**A RESOLUTION OF  
THE BOARD OF DIRECTORS OF  
CUYAMA BASIN GROUNDWATER SUSTAINABILITY AGENCY  
ENACTING CORRECTIVE ACTIONS IN RESPONSE TO THE CALIFORNIA  
DEPARTMENT OF WATER RESOURCES' CONSULTATION LETTER  
DATED JUNE 3, 2021**

RE: Cuyama Valley - 2020 Groundwater Sustainability Plan

TO: Craig Altare, California Department of Water Resources  
PREPARED BY: Woodard & Curran on Behalf of the Cuyama Valley Groundwater Basin Groundwater Sustainability Agency  
DATE: November 5, 2021  
RE: **Cuyama Basin GSA Response to DWR's June 3, 2021, Consultation Letter**

Figure 2-2. Well Status Based on Minimum Threshold Analysis

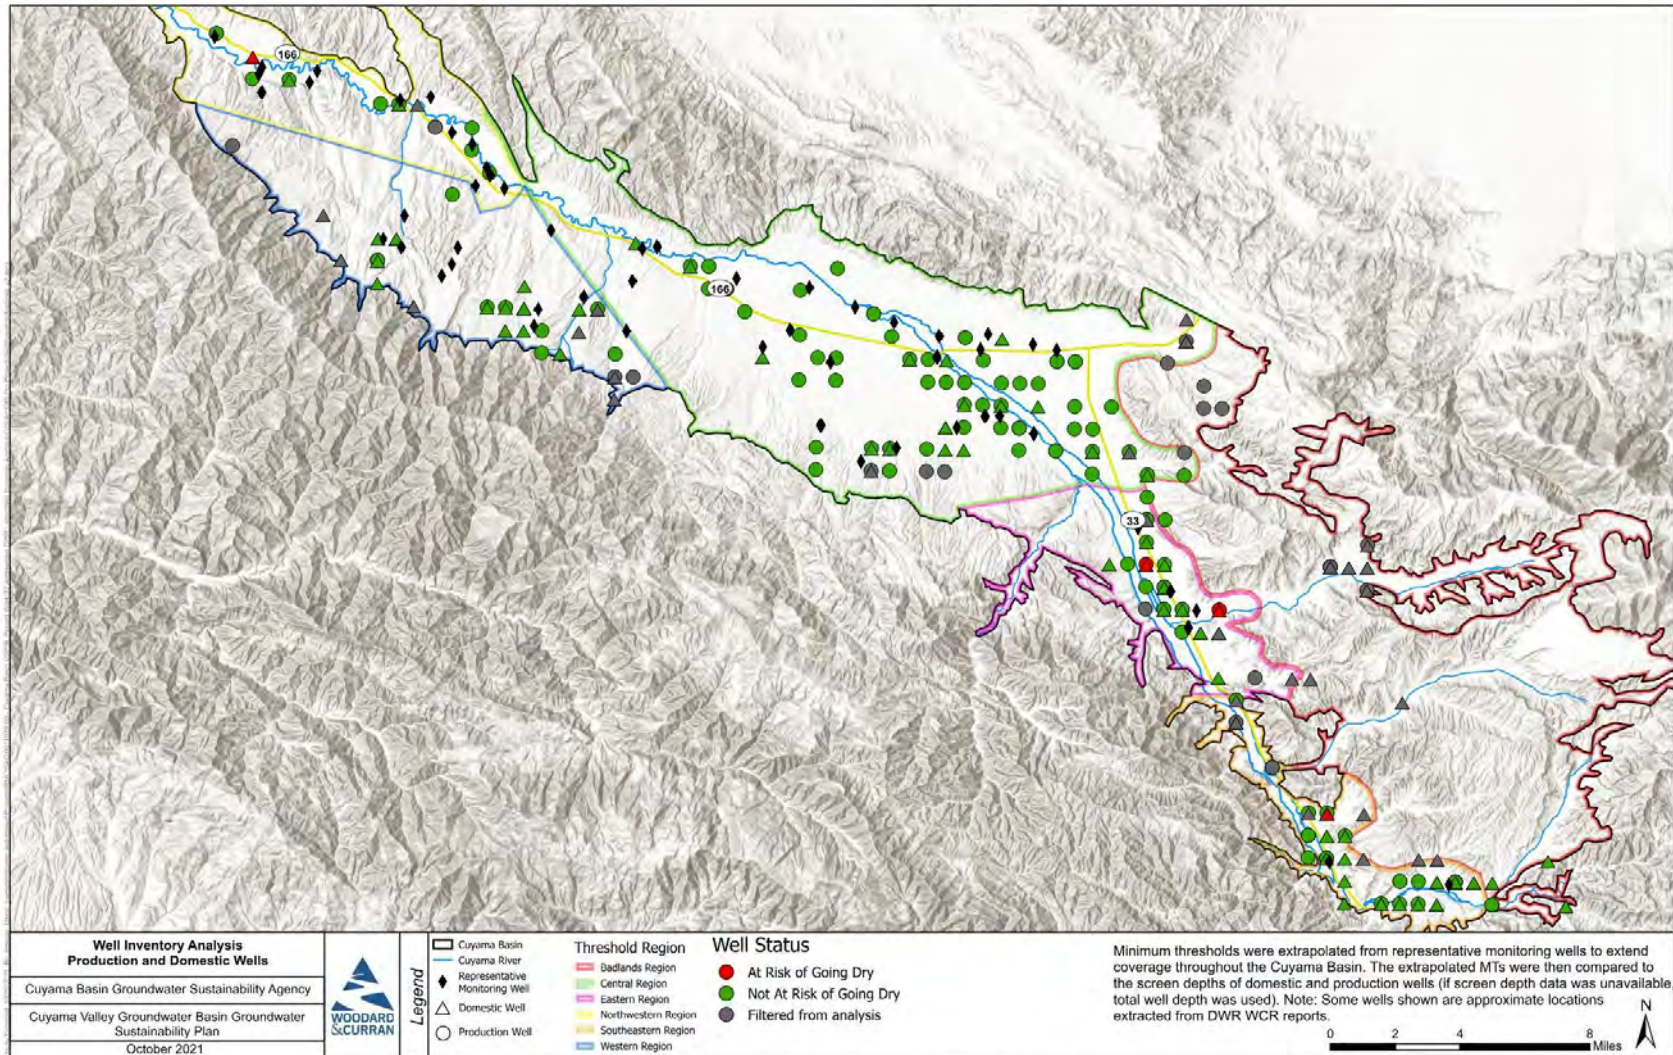
The GSA must provide more detailed information, as required in the GSP Regulations, regarding undesirable results and minimum thresholds for all applicable threshold regions.<sup>16</sup> The GSA should describe the anticipated effects of the established minimum thresholds and undesirable results on the interests of beneficial uses and users and how the GSA determined that those thresholds would avoid undesirable results in the Basin. Department staff suggest that the following issues be considered and addressed:

The results of the analysis are shown in Table 2-2 and Figure 2-2. Out of a total of 250 production wells that were evaluated, a total of seven (3% of the total) are at risk of going dry if minimum thresholds are reached. Four of these seven wells are domestic wells. As noted above, the CBGSA will strive to use adaptive management to prevent these domestic wells from going dry.

Figure 2-3. Change in Groundwater Levels in Northwestern Region from CBWRM Test Simulation

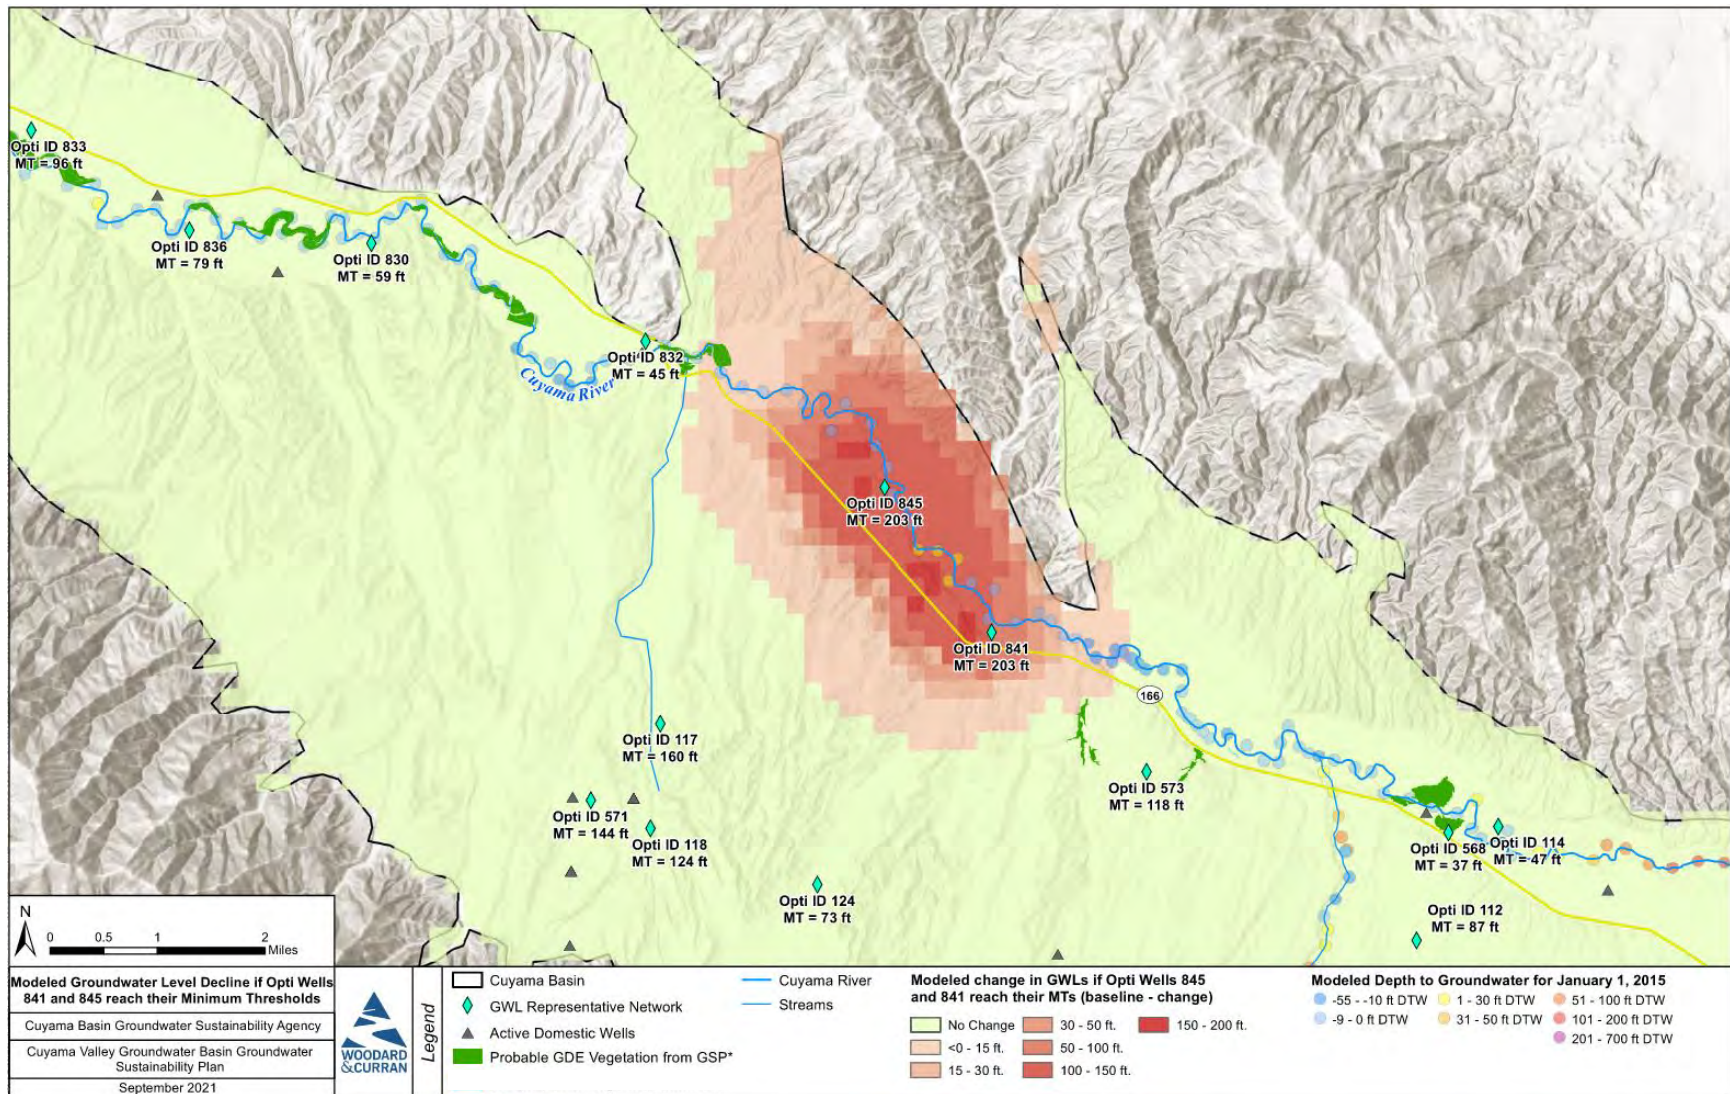
region is to “...protect the water levels from declining significantly, while allowing beneficial land surface uses (including domestic and agricultural uses) and using the storage capacity of this region.”<sup>12</sup> However, the Northwestern region is the only region in the Basin where the sustainable management criteria indicate a plan to substantially lower groundwater levels, relative to conditions at the time of GSP preparation (i.e., the minimum thresholds for groundwater levels are up to 140 to 160 feet lower<sup>13</sup>), in an area with the highest concentration of potential GDEs<sup>14</sup> in Cuyama Valley and with interconnected surface water, which is evidenced by a gaining reach of the river.<sup>15</sup> The GSP did not quantify the expected depletions of surface water over time or assess or disclose the anticipated effects of the established minimum thresholds on beneficial uses and users of groundwater, which, based on Department staff’s review, appear to include nearby domestic users, potential GDEs, and users of the interconnected surface water.

Figure 2-3 shows the modeled change in groundwater elevations resulting from setting groundwater levels at the minimum thresholds at wells 841 and 845. Areas shaded in red or tan color on the figure had reduced groundwater elevations as compared to the baseline condition. Areas shaded in lime green were unaffected by the change in groundwater elevations at the well 841 and 845 locations. As shown in the figure, there are no active domestic wells within the area affected by the lowered groundwater elevations at wells 841 and 845. The only GDE which may be affected is the GDE located at the confluence of Cottonwood Creek and the Cuyama River, which has an expected impact of less than 5 feet. However, even with this difference the estimated depth to water at this GDE location would be shallower than 30 feet. Potential impacts on this GDE location will be monitored at nearby Opti well 832.

As noted above, the other potential beneficial use that may be affected comes from Cuyama River inflows into Lake Twitchell. The model simulation also showed an increase in stream depletion in the affected portion of the aquifer of about 1,200 acre-feet per year. This represents about 12 percent (out of 10,200 afy) of the modeled streamflow in the Cuyama River at this location during the WY 2011-2020 model simulation period. However, the actual change in inflows into Lake Twitchell would be less than 1,200 afy because of stream depletions that would occur between Cottonwood Creek and Lake Twitchell. For comparison, during the same period the USGS gage on the Cuyama River just upstream of Lake Twitchell (11136800) recorded an average annual flow of 7,900 afy, only a portion of which comes from the Cuyama Basin. Given the lack of data regarding the hydrology and stream seepage between Cottonwood Creek and Lake Twitchell, it is uncertain how much of an impact this would have on the flows that ultimately are stored in Lake Twitchell.

Figure 3-1. Potential Stream Interconnectivity using Historical Modeled Groundwater Levels in January 2015

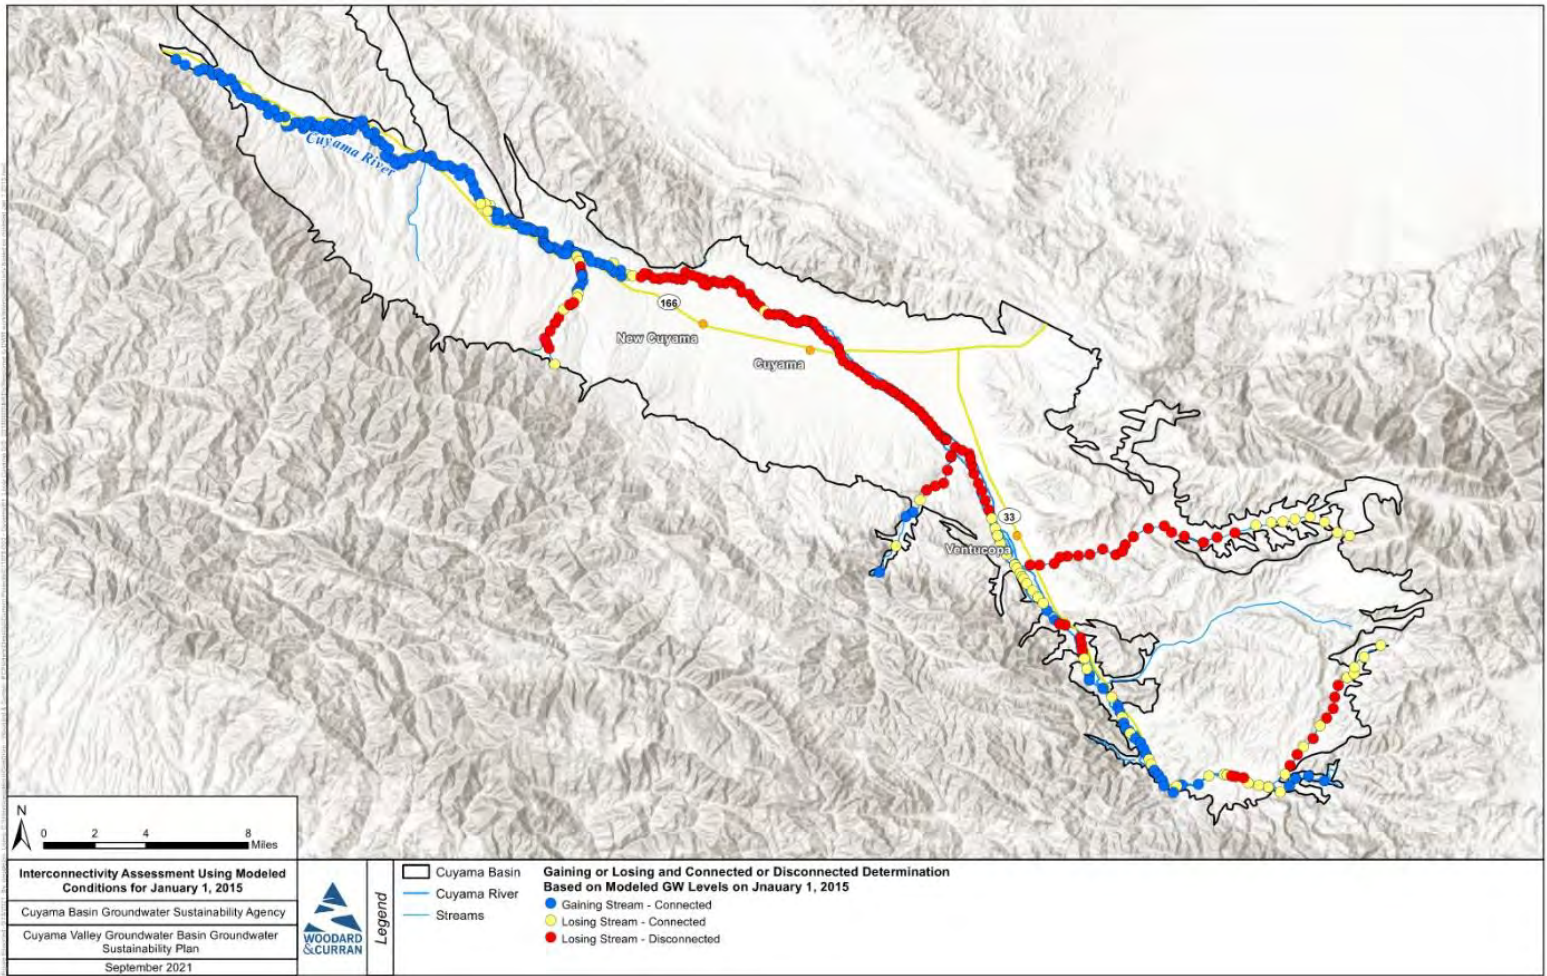
The GSA should provide a demonstration, with supporting evidence, for why using the basinwide groundwater level minimum thresholds is a reasonable proxy for thresholds for depletion of interconnected surface water.

Depletions of ISW are related to chronic lowering of groundwater levels via changes in the hydraulic gradient. Therefore, declines in groundwater elevations in portions of the river system that are hydrologically connected to the river system can lead to increased depletions of surface water. As shown in Figure 3-1, an analysis of the results of the historical simulation of the Cuyama Basin Water Resources Model (CBWRM) reveals that many portions of the stream system in the basin were already disconnected as of 2015 and therefore ISW flows in these stream reaches would not be affected by changes in groundwater levels. The primary areas of concern for ISW are on stretches of the Cuyama River upstream of Ventucopa and downstream of the Russell Fault.

that may flow into Lake Twitchell downstream of the basin boundary. Lowering groundwater levels could result in reduced streamflows for beneficial use by these users. Therefore, the intent of the ISW monitoring network and sustainability criteria is to ensure that long-term groundwater level declines do not occur in the vicinity of the connected stretches of the Cuyama River.

Figure 4-1. Average Well Measurements of Nitrate (as N) from 2010 through 2020

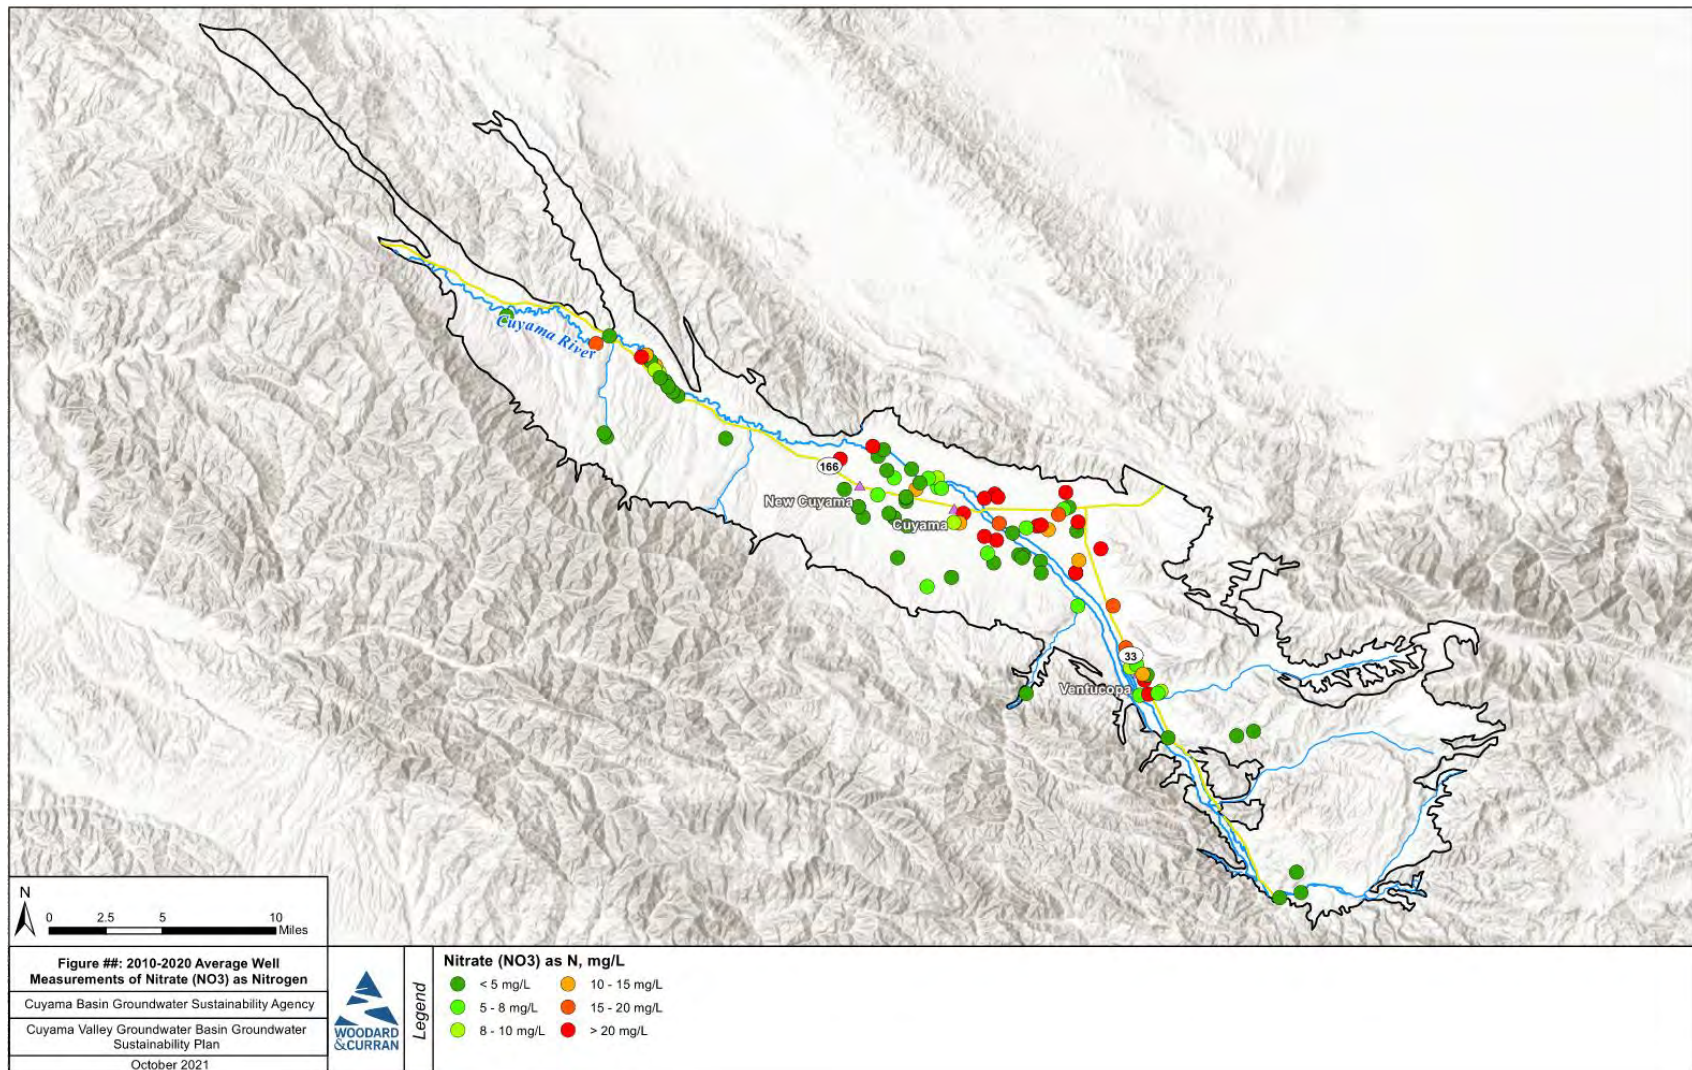
Regarding nitrates, a public comment submitted to the Department indicates that potentially 13 of 109 nitrate samples (12 percent) have exceeded the MCL in the past ten years,<sup>32</sup> which conflicts with the GSP's statement that only two samples during 2011 to 2018 exceeded the MCL.

Summary statistics for nitrate (as N) and arsenic measurements taken from 2010-2020 are shown in Table 4-1. For nitrates, 41 of the 102 wells with measurements during this period recorded a measurement exceeding the MCL of 10 mg/L. For arsenic, 5 of the 23 wells with measurement recorded a measurement exceeding the MCL of 10 µg/L. Figures 4.1 and 4.2 show the locations of wells with monitoring measurements for nitrates and arsenic during the 2010-2020 period and the average concentrations measured in each well. In each case, the wells with average values exceeding the MCLs correspond with the wells tabulated in Table 4-1. A review of the data for wells with measurements both before and after 2015 showed little change with no wells showing degradation of nitrate or arsenic such that a well that was below the MCL before 2015 was above the MCL afterwards.

As shown in Figures 4-1 and 4-2, most wells with nitrate and arsenic concentrations exceeding MCLs are located in the central threshold region. The locations of high arsenic concentrations are focused to the south of the town of New Cuyama near the existing Cuyama Community Services District (CCSD) well. This is a known issue for the CCSD that will be mitigated by the construction of a replacement well for the district, which was included as a project in the GSP (see section 7.4.4).

Figure 4-2. Average Well Measurements of Arsenic from 2010 through 2020

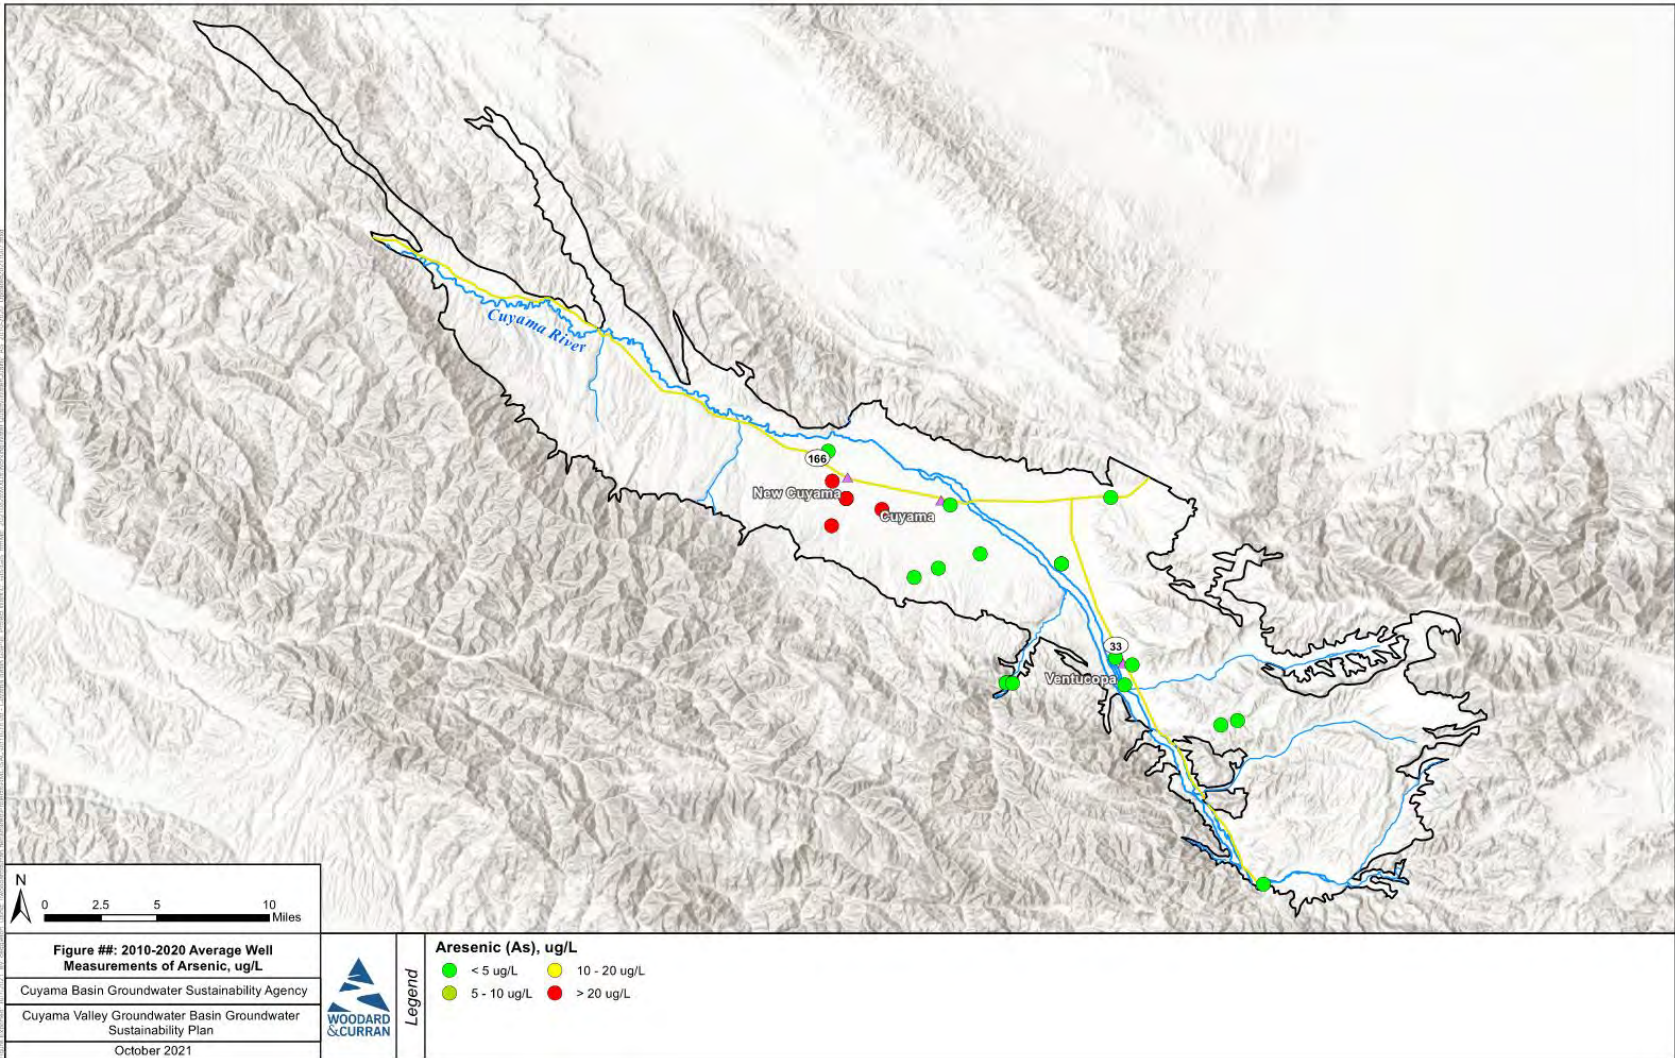
2. Sustainable management criteria. After updating the information regarding existing groundwater quality conditions, the GSA should revise its discussion of groundwater quality sustainable management criteria to either include criteria for arsenic and nitrate or provide thorough, evidence-based descriptions for why

Similarly, because arsenic is naturally occurring, the CBGSA does not believe the establishment of thresholds for arsenic is appropriate. As shown in Figure 4-2, wells with high arsenic concentrations are located in a relatively small area of the basin south of New Cuyama. A review of production well data provided by the counties (discussed in Section 2) indicates that there are no active private domestic wells located in this part of the basin. The only operational public well that is located in this part of the basin serves the Cuyama Community Services District (CCSD). As noted above, the CCSD is currently pursuing the drilling of a new production well, which was included as a project in the GSP. Once this well is completed, it is not believed that any domestic water users will be using a well that accesses groundwater with known high arsenic concentrations.
